GeoMat Testing Laboratories, Inc.

Project No. 16027-01

SUBJECT: Response to County of San Bernardino Review Sheet Dated December 20, 2016, Proposed Islamic Community Center, Northwest Corner of Beaumont Avenue and Nevada Street, APN 0293-111-15-0000, Redlands, California.

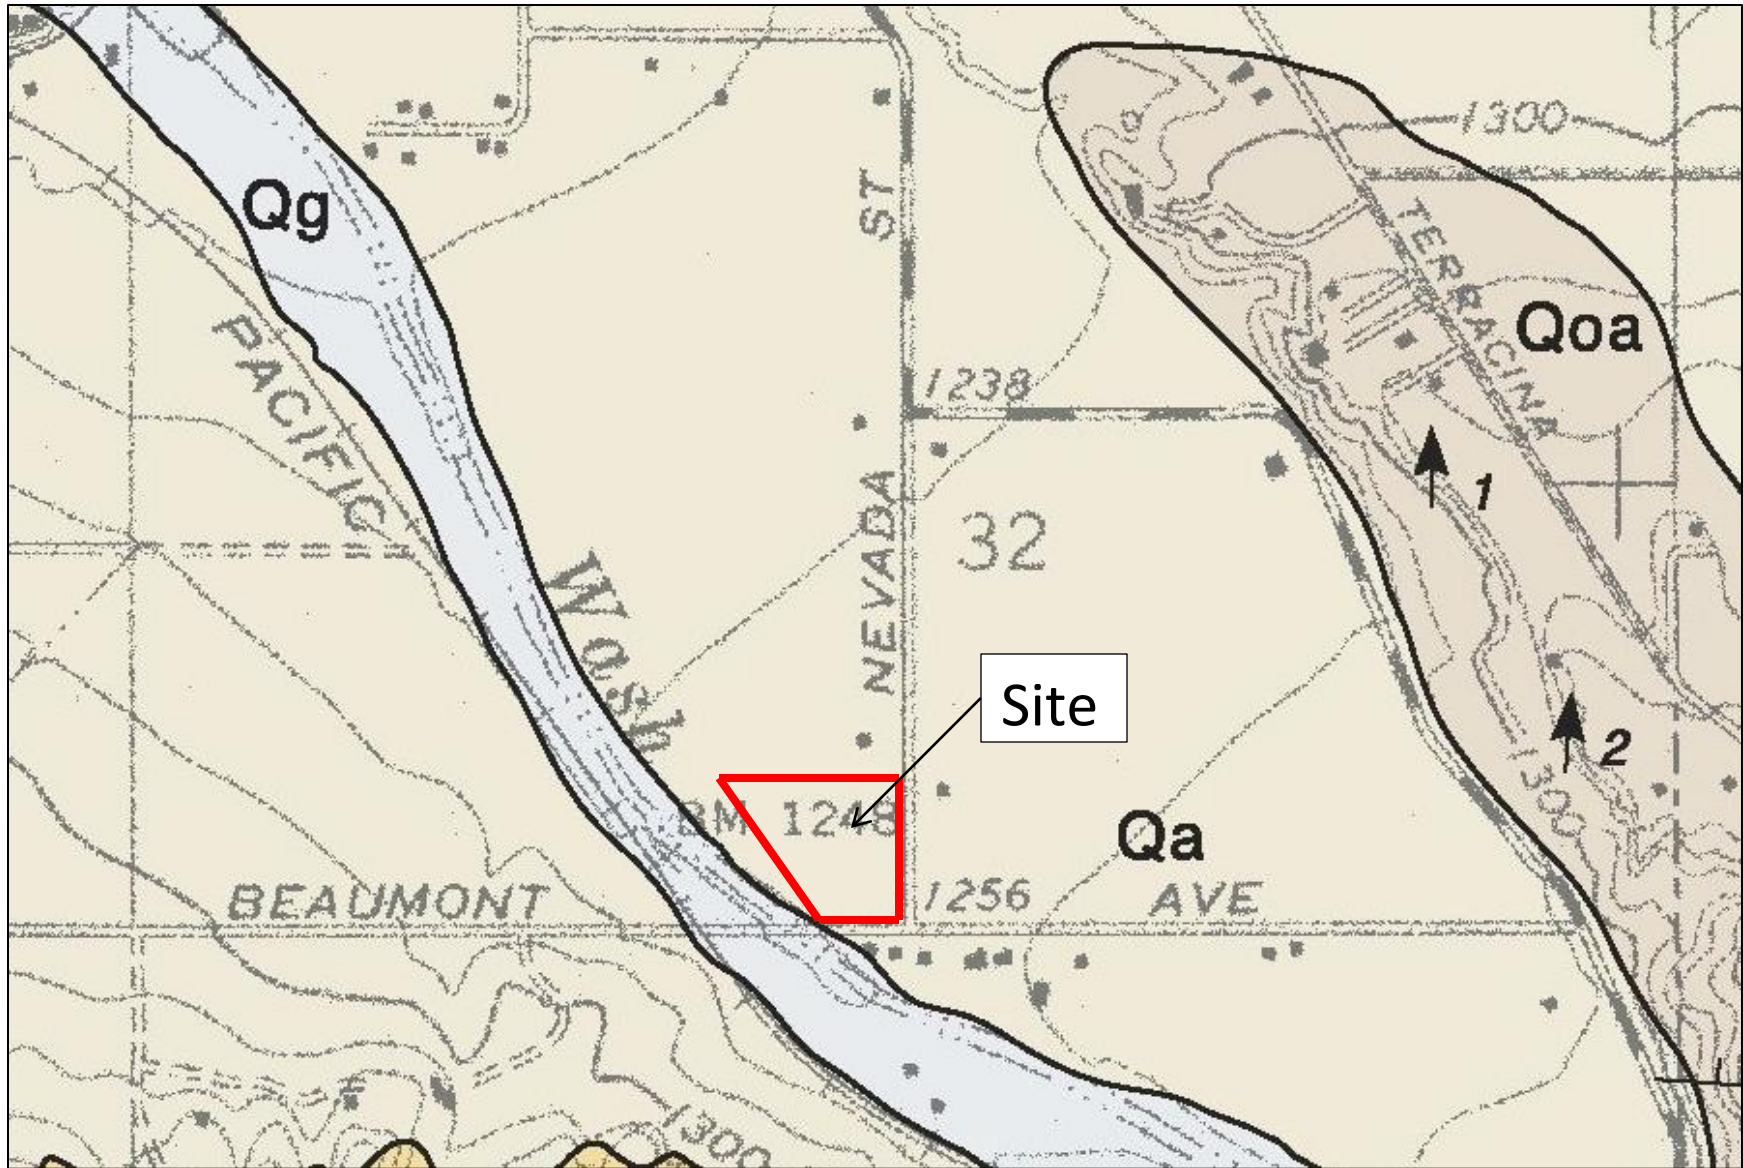
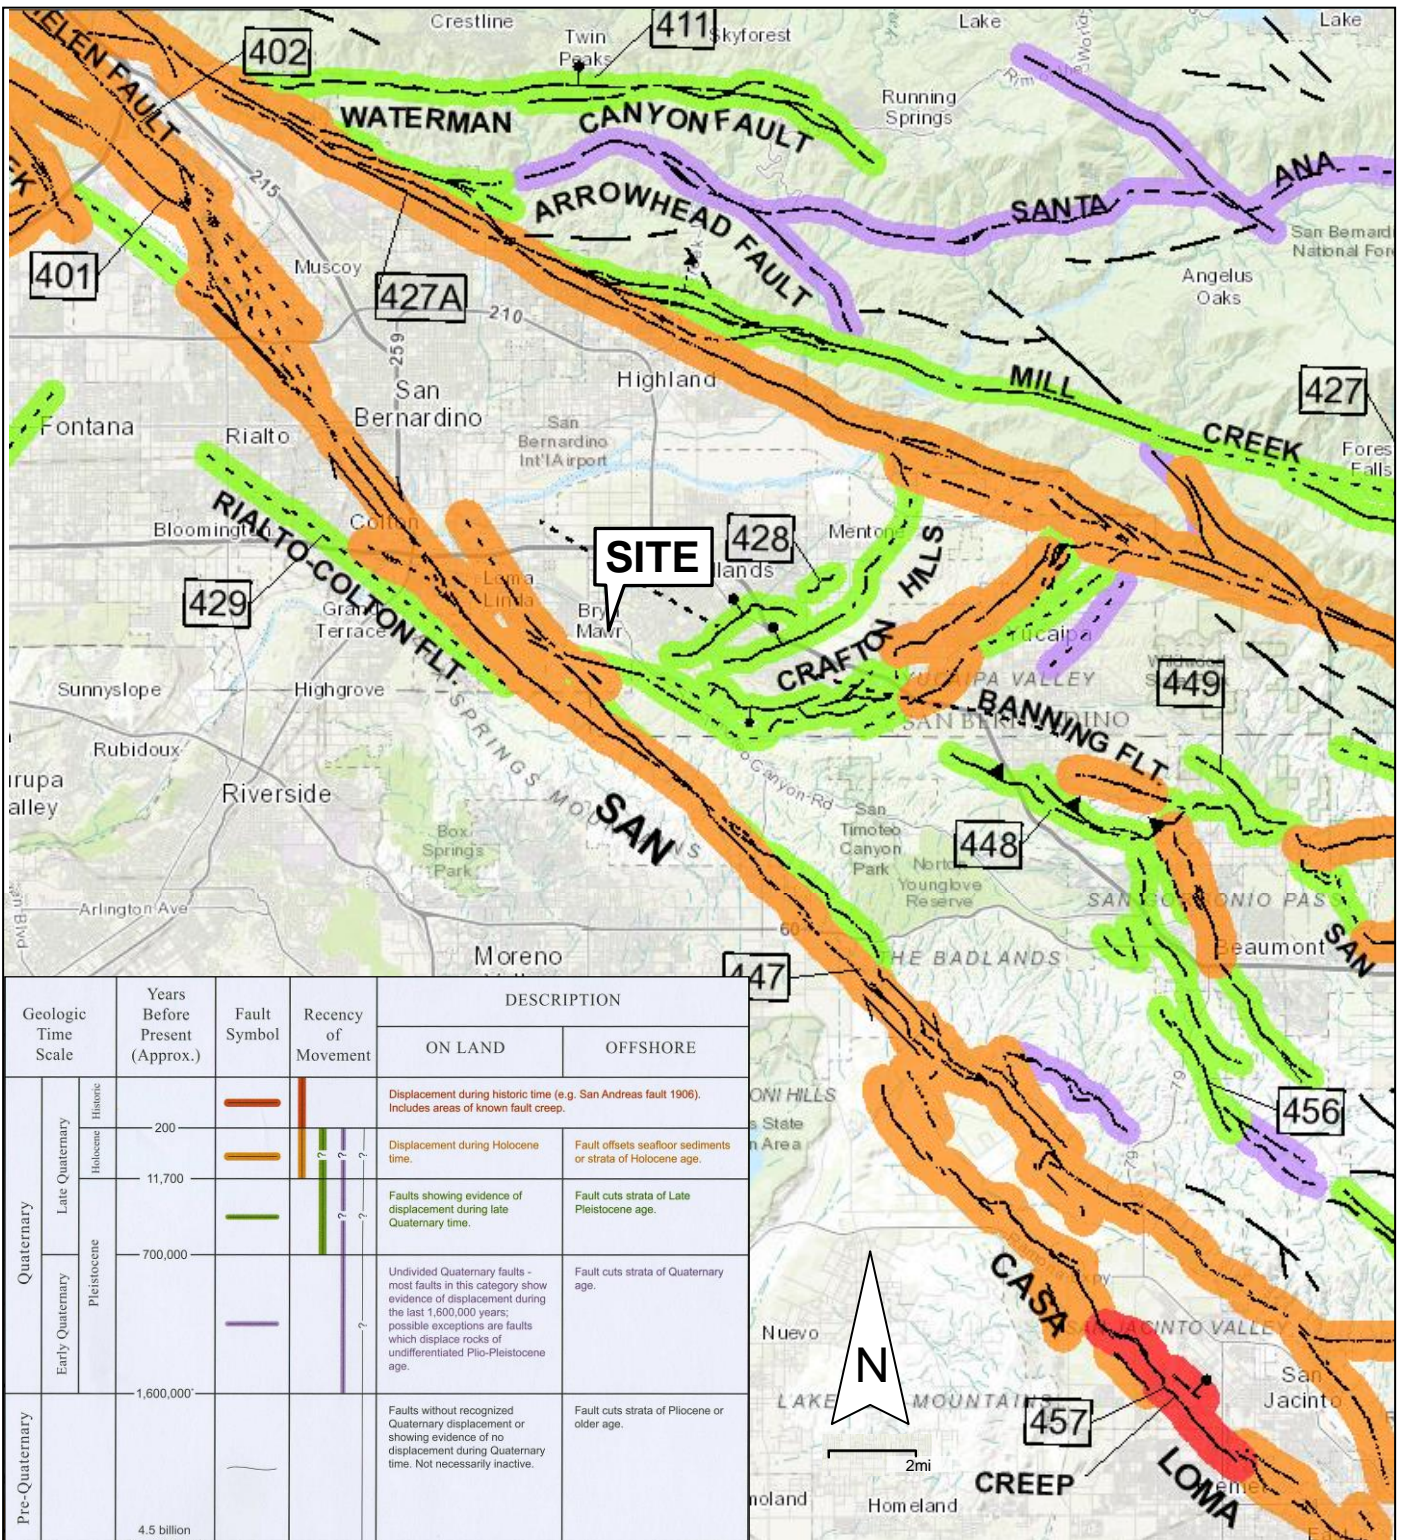
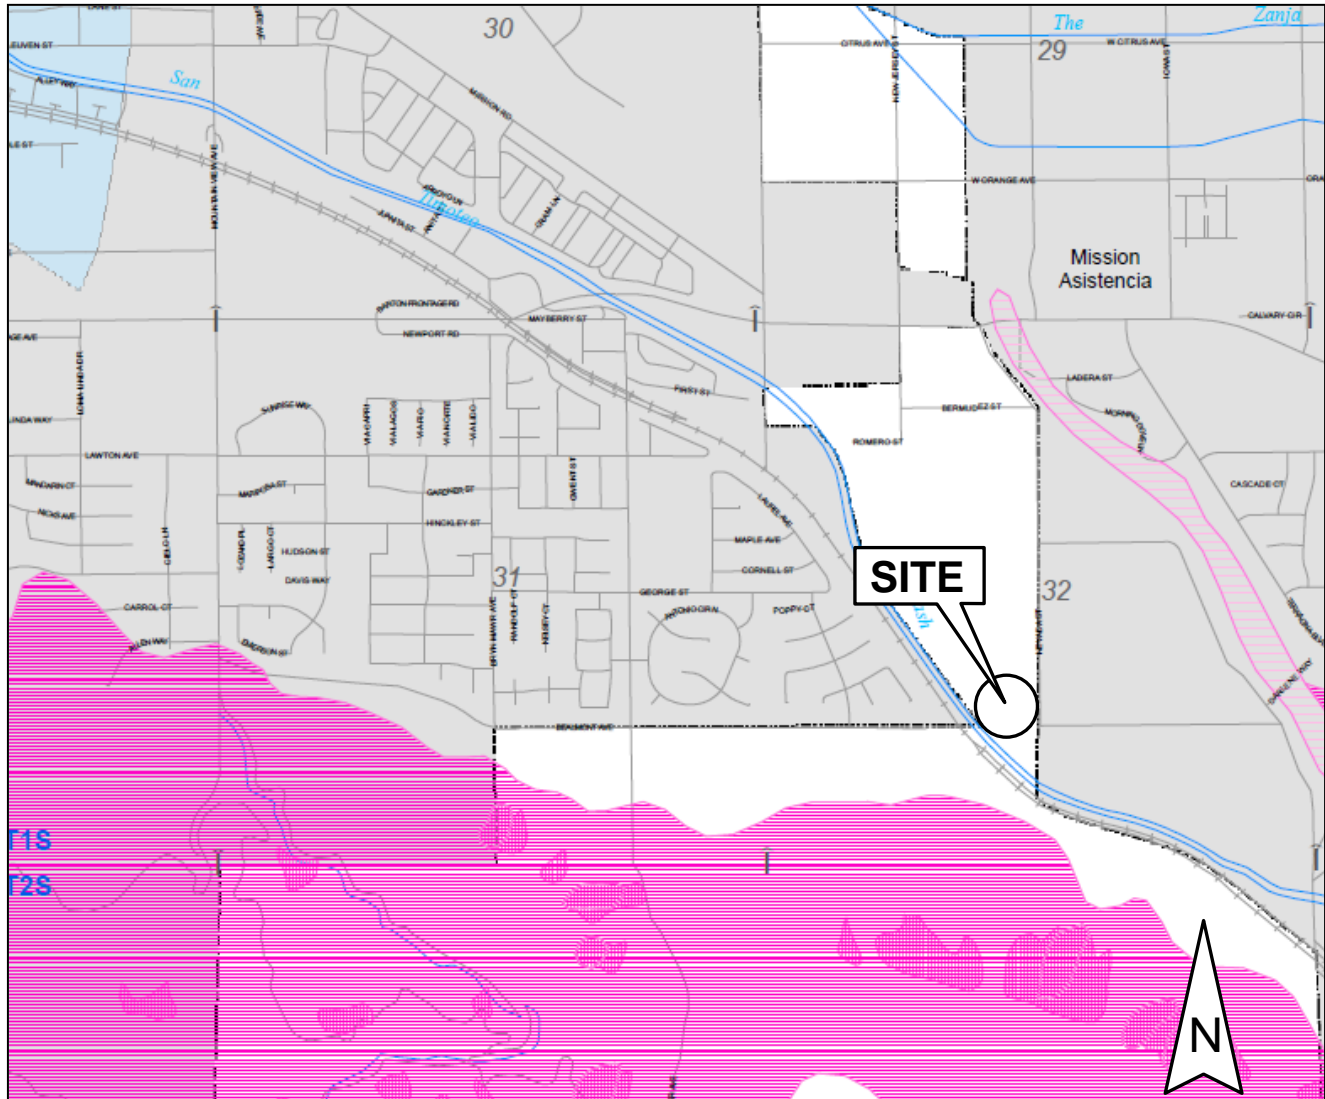
Item 3

The engineering geologist has revised the geology section of the report. He also added additional figures and paragraphs such as Regional Faulting and Seismic Hazards, and Secondary Seismic Hazards.
